UNITED STATES
DEPARTMENT OF THE INTERIOR
BUREAU OF LAND MANAGEMENTNMOCD
ArtesiaFORM APPROVED
OMB NO. 1004-0137
Expires: January 31, 2018**SUNDRY NOTICES AND REPORTS ON WELLS**
*Do not use this form for proposals to drill or to re-enter an abandoned well. Use form 3160-3 (APD) for such proposals.*5. Lease Serial No.
NMNM92155

SUBMIT IN TRIPLICATE - Other instructions on page 27. If Unit or CA/Agreement, Name and/or No.
NMNM1110378. Well Name and No.
LUMINARY BAU FEDERAL COM 29. API Well No.
30-005-6356710. Field and Pool or Exploratory Area
LEA LAKE; PRE-PERMIAN11. County or Parish, State
CHAVES COUNTY, NM**12. CHECK THE APPROPRIATE BOX(ES) TO INDICATE NATURE OF NOTICE, REPORT, OR OTHER DATA**

**Luminary BAU Federal Com 2
30-005-63567
EOG Y RESOURCES, INC.
July 23, 2018
Conditions of Approval**

Before

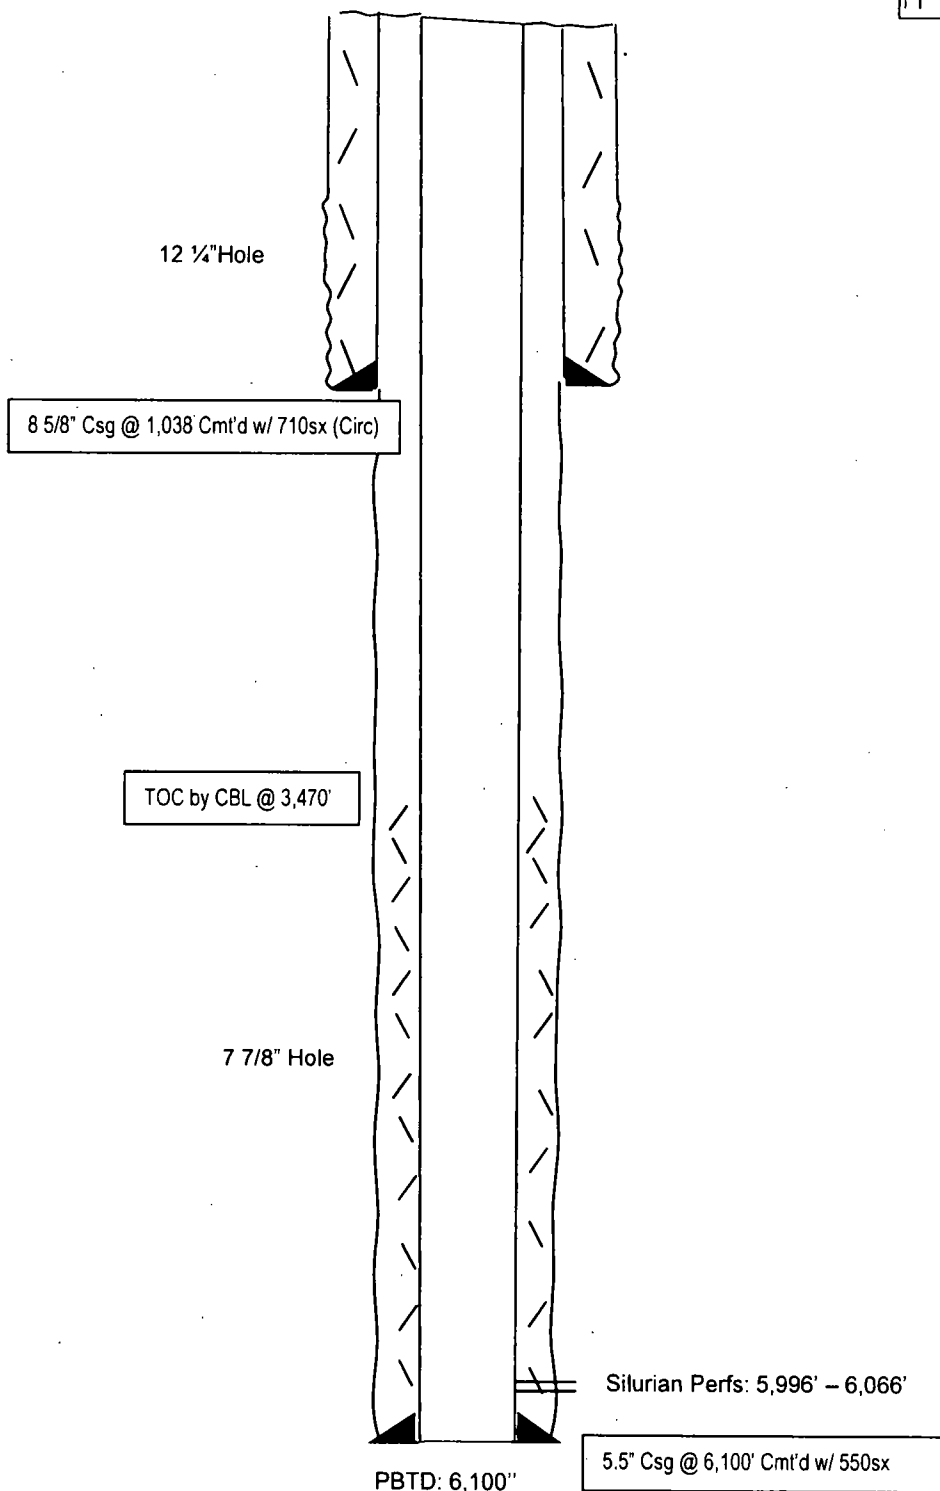
Queen	287'
Grayburg	674'
San Andres	926'
Glorieta	2,122'
Tubb	3,634'
Abo	4,417' ✓
Wolfcamp	5,136' ✓
Cisco	5,736' ✓
Strawn	5,891'
Siluro	5,993' ✓

After

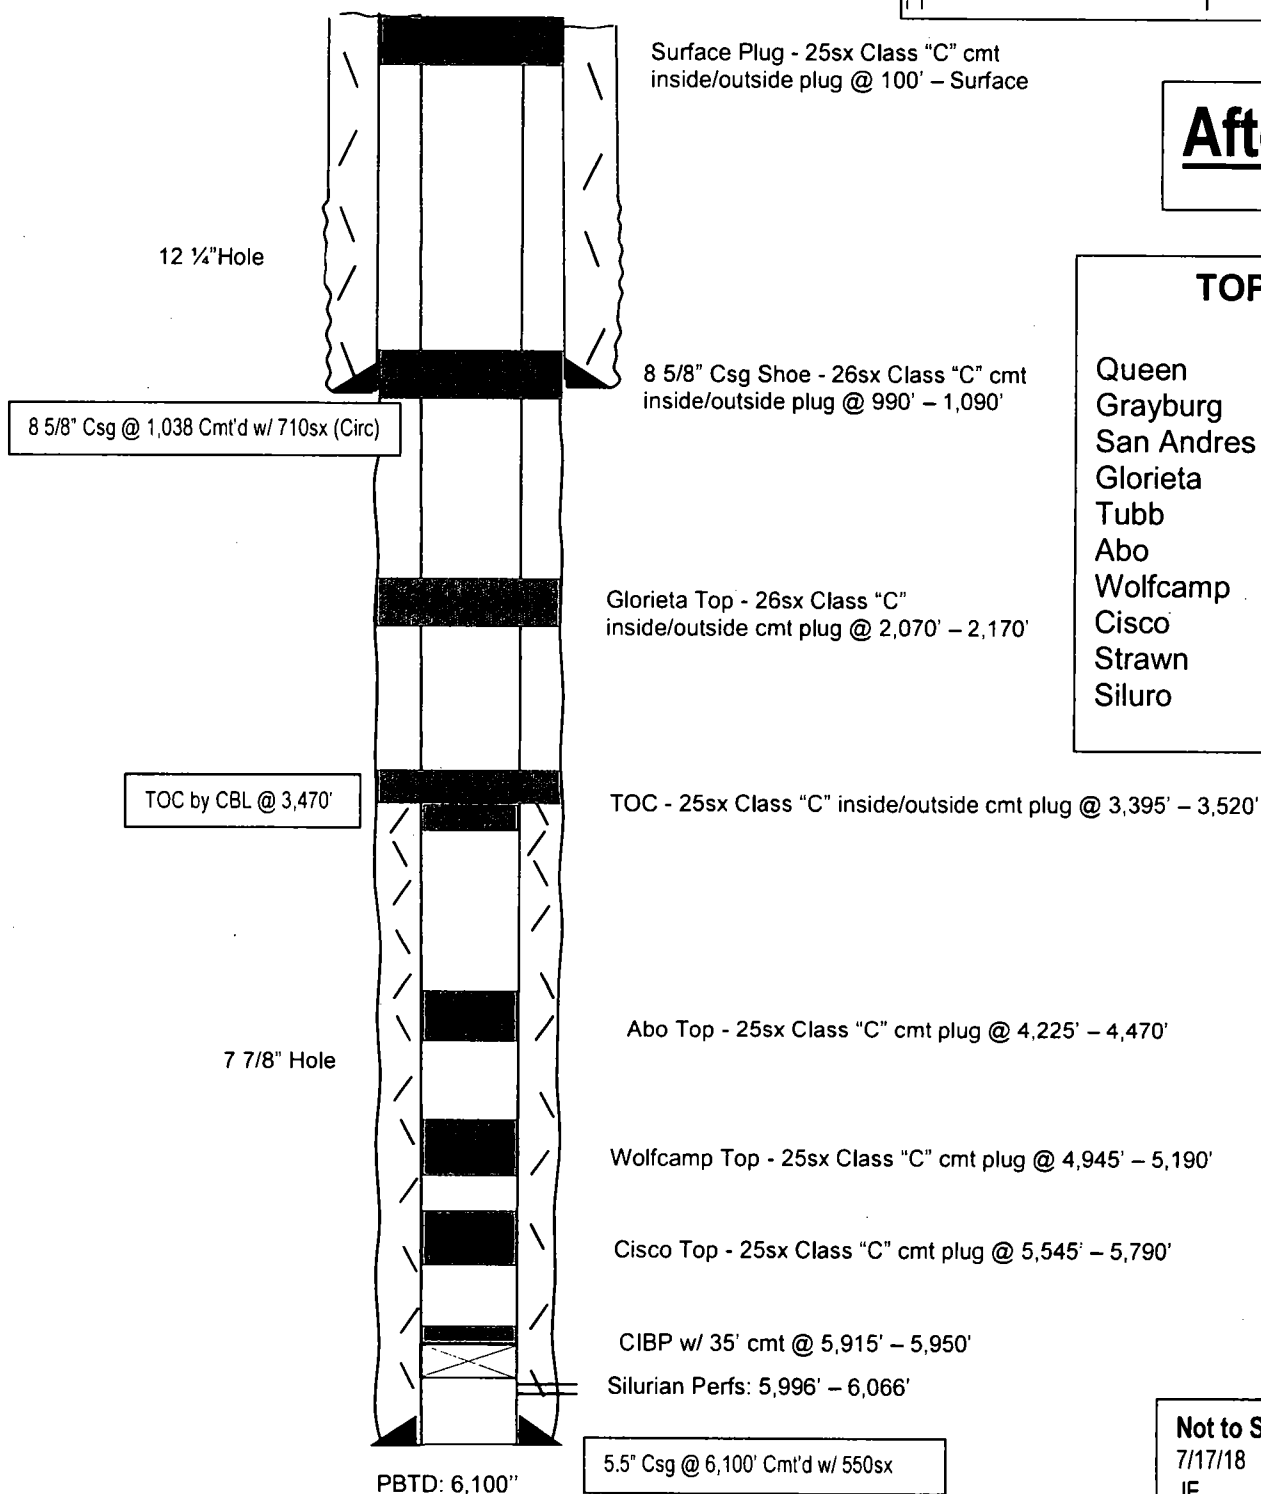
1. MIRU all safety equipment as needed. Pull production equipment.
2. RIH with GR/JB to 5975 ft.
3. Set a CIBP at 5950 ft with 35 ft cement on top. This will place a plug over open perforations. WOC and tag. **5546'**
4. Load the hole with plugging mud.
5. Spot a 25 sx Class C cement plug from 5545 ft - 5790 ft. This will place a plug over Cisco top
6. Spot a 25 sx Class C cement plug from 4945 ft - 5190 ft. This will place a plug over Wolfcamp top.
7. Spot a 25 sx Class C cement plug from 4225 ft - 4470 ft. This will place a plug over Abo top
8. Perforate at 3450 ft.

9. Spot a 25 sx Class C inside/outside cement plug from 3395 ft ? 3520 ft. This will place a plug over TOC, WOC and tag.
10. Perforate at 2170 ft.
11. Spot a 26 sx Class C inside/outside cement plug from ~~2070~~ ²⁰⁵⁰ ft ? 2170 ft. This will place a plug over Glorieta top, WOC and tag.
12. Perforate at 1090 ft.
13. Spot a 26 sx Class C inside/outside cement plug from 990 ft - 1090 ft. This will place a plug over the 8 5/8 inch casing shoe, WOC and tag.
14. Perforate at 100 ft.
15. Spot a 25 sx Class C inside/outside cement plug from 100 ft up to surface.
16. Cut off wellhead. Install dry Hole marker and clean location as per regulated.

- 1. Operator shall place CIBP at 5,946' (50'-100' above top most perf) and place 35' of Class C cement on top as proposed. WOC and TAG.**
- 2. Operator shall place a balanced Class C cement plug from 5,790'-5,545' as proposed.**

- 3. Operator shall place a balanced Class C cement plug from 5,190'-4,945' to seal the top of the Wolfcamp Formation.**
- 4. Operator shall place a balanced Class C cement plug from 4,470'-4,225' to seal the top of the Abo Formation.**

- 5. Operator shall perf and squeeze at 3,450'. Operator shall place a balanced Class C cement plug from 3,520'-3,395' as proposed. WOC and TAG.**
- 6. Operator shall perf and squeeze at 2,170'. Operator shall place a balanced Class C cement plug from 2,170'-2050' to seal the Glorietta formation. WOC and TAG.**

- 7. Operator shall perf and squeeze at 1,090'. Operator shall place a balanced Class C cement plug from 1,090'-990' to seal the shoe. WOC and TAG.**
- 8. Operator shall perf and squeeze at 100' bringing cement to surface.**
